APPLICATION FOR CERTIFICATE OF APPROPRIATENESS

Address 2010-2012 Venable

2010-2012 VENABLE ST. HOUSES

SET/REVISION:
REVISION 01:
ADDITION SIDING
DATE/MARK:
03.08.2021

A2.1

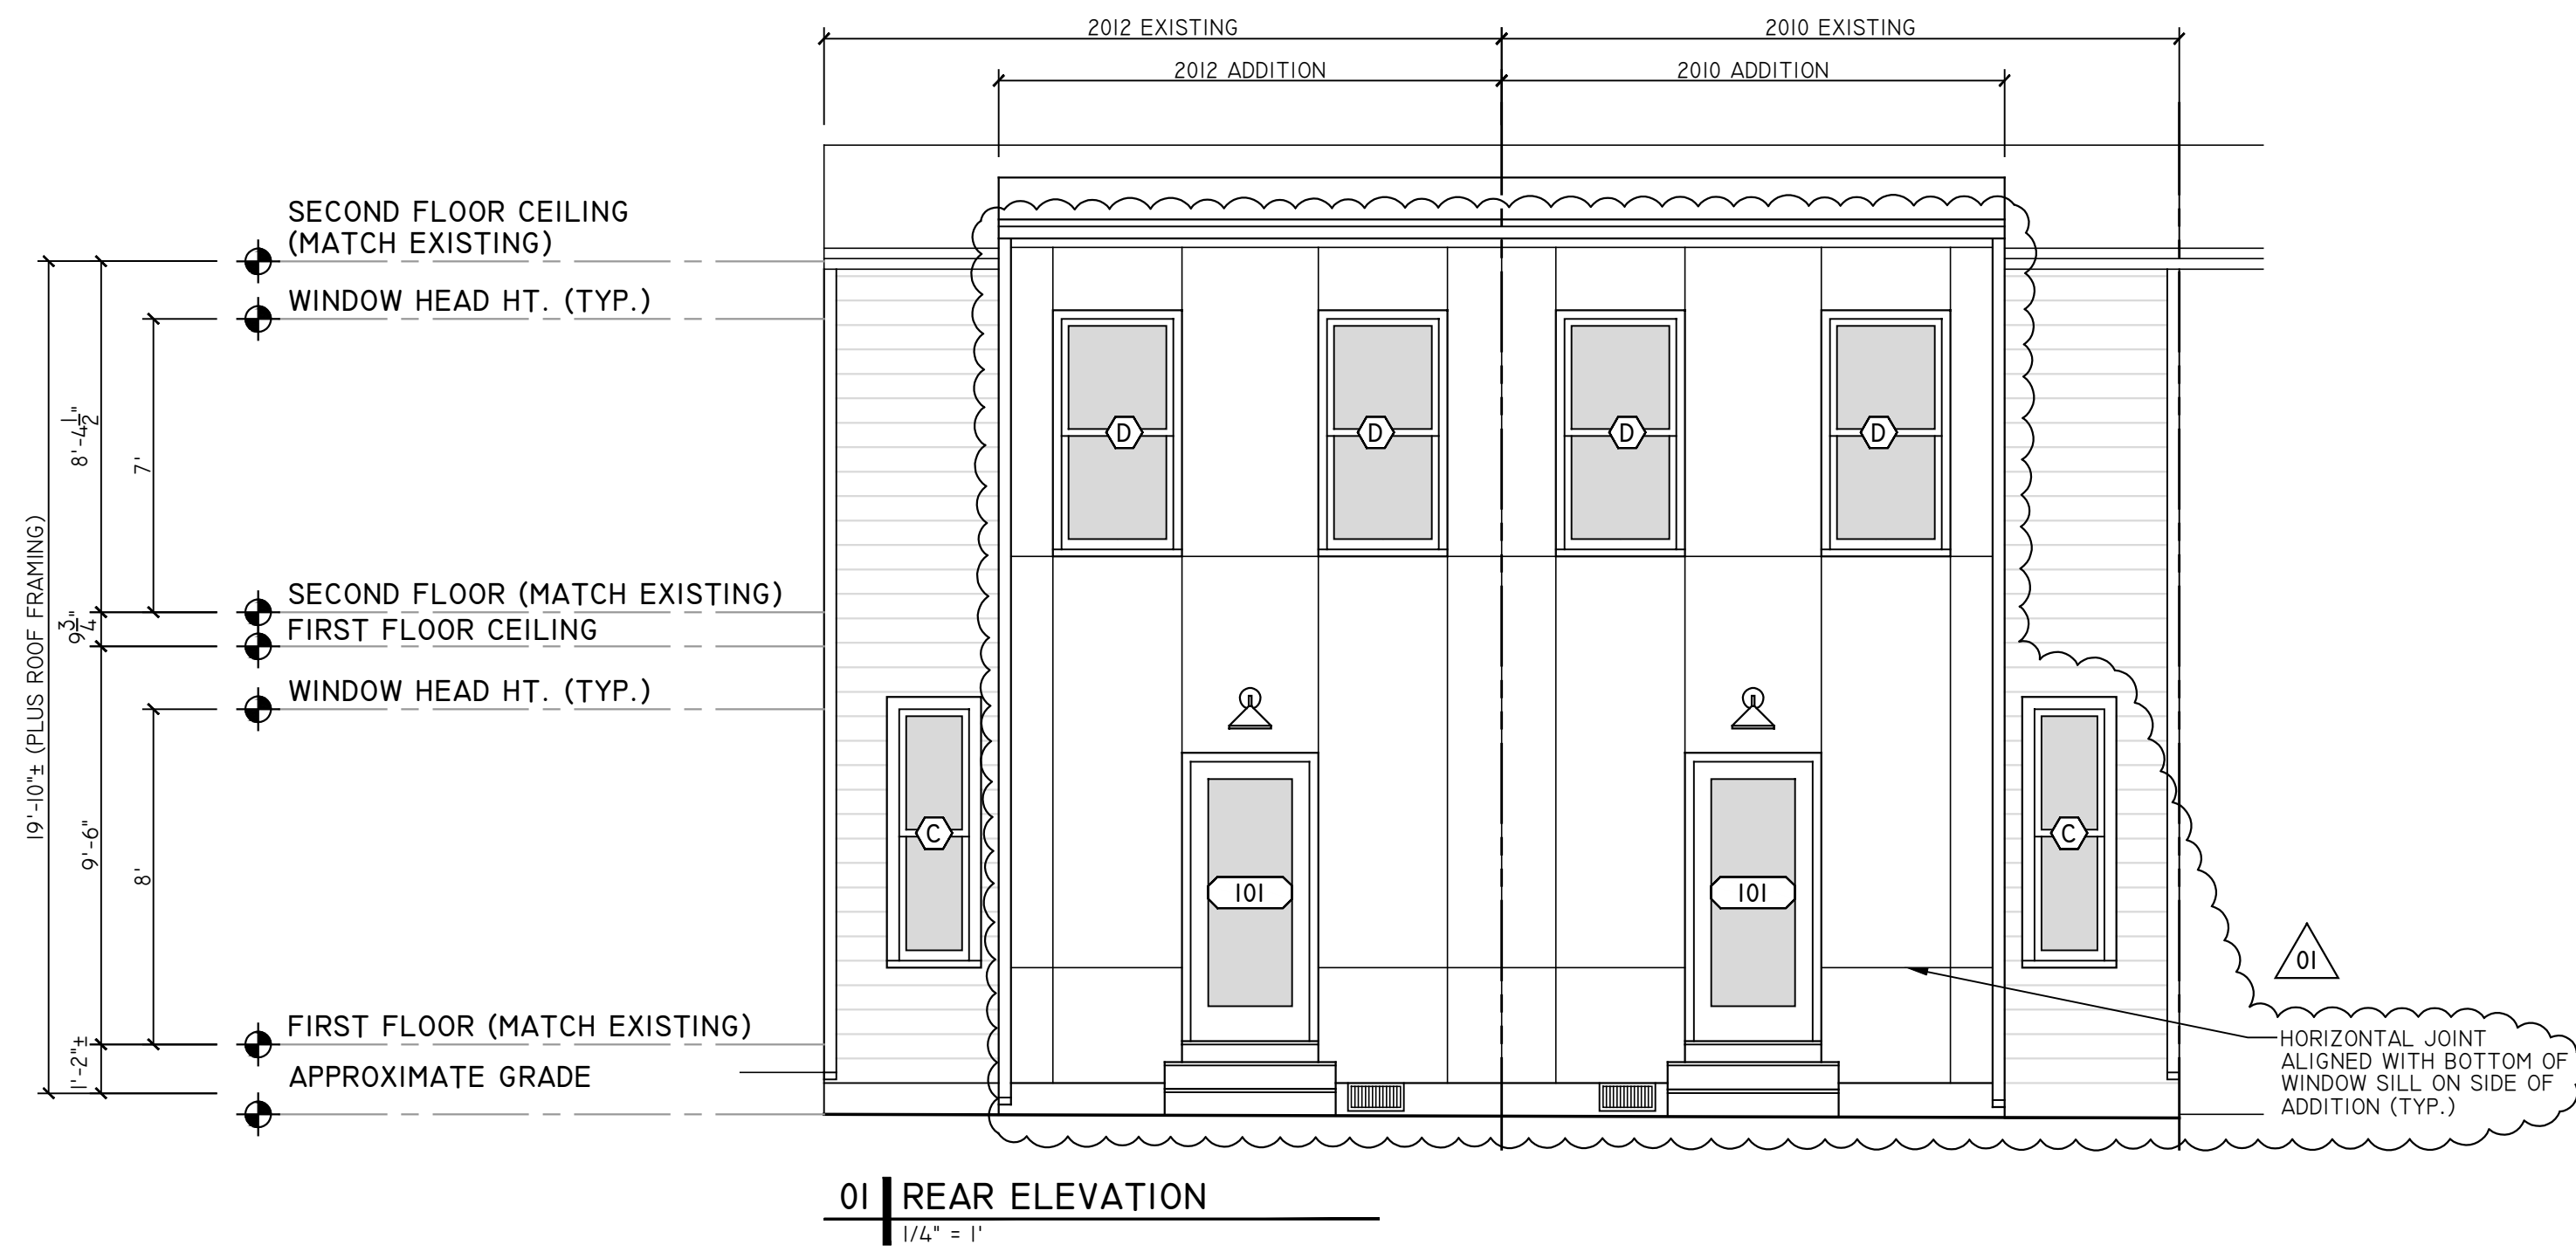
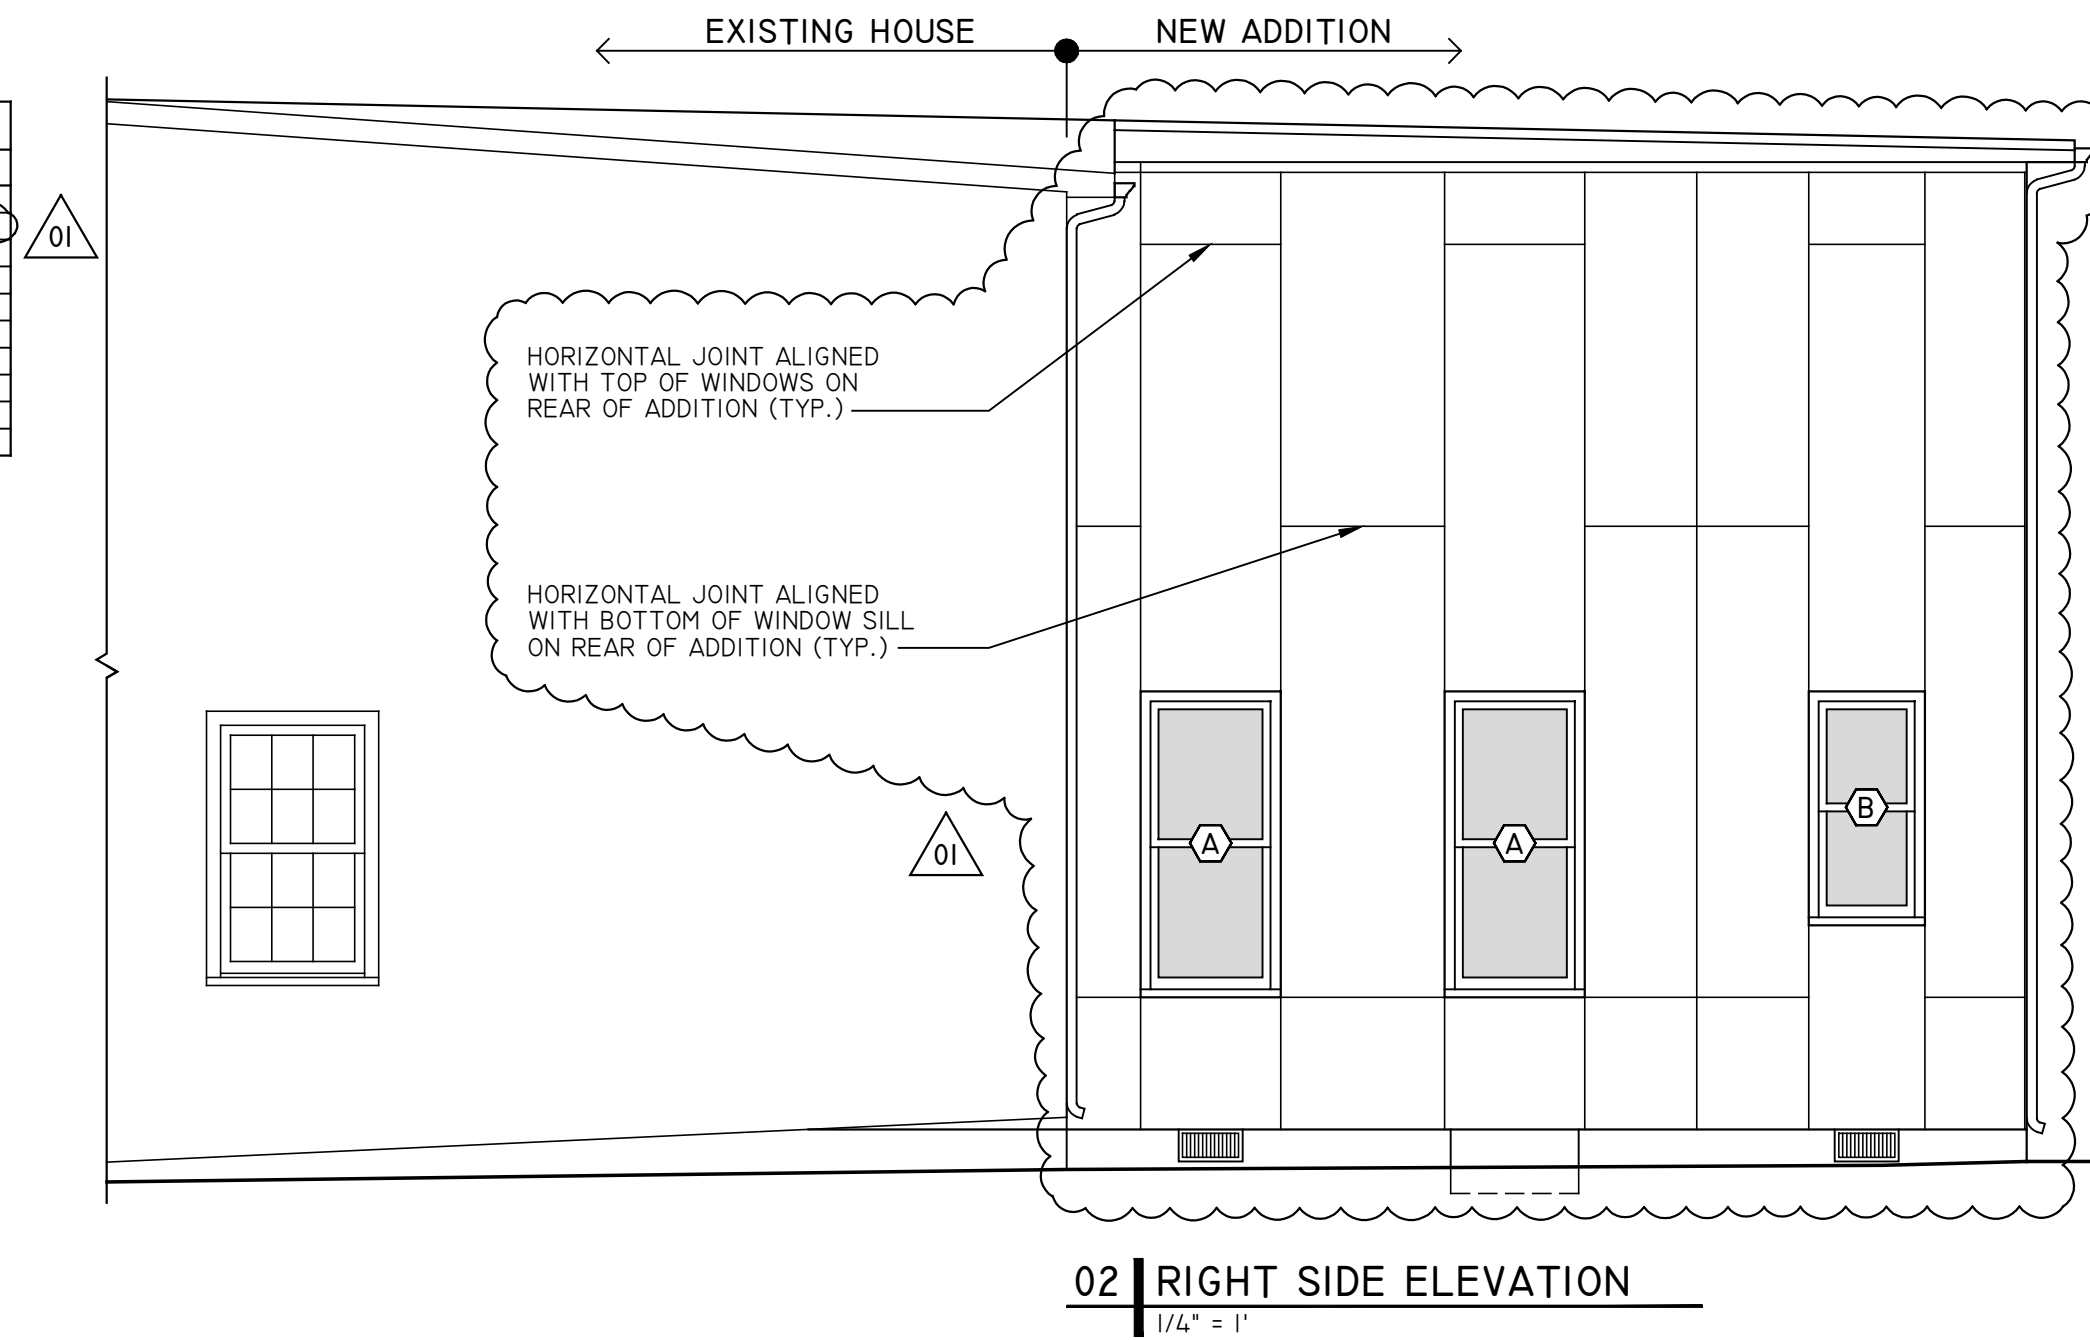
REVISION 01	03-08-2021	- ADDITION SIDING REVISED TO BE HARDIE PANEL SIDING- ELEVATIONS & WALL SECTION REVISED
-------------	------------	--

EXTERIOR FINISH SCHEDULE		
NO.	COMPONENT/MATERIAL	COLOR/FINISH
01	PARGED FOUNDATION	DARK GRAY
02	HARDIE SMOOTH PANEL SIDING WITH ALUM. ACCESSORIES	TBD
03	HARDIE/COMP. TRIM	PAINTED WHITE
04	MAIN ROOF - TPO	FACTORY WHITE
05	NEW FRONT PORCH ROOF - EPDM MEMBRANE	FACTORY BLACK
06	SOLID WOOD ENTRY DOORS	PAINTED- COLOR TBD
07	WINDOW	WRAPPED WOOD, PREFINISHED WHITE
08	NEW FRONT PORCH RAILINGS - "RICHMOND RAIL"	PAINTED WHITE
09	ALUMINUM GUTTER & DOWNSPOUTS	PREFINISHED WHITE
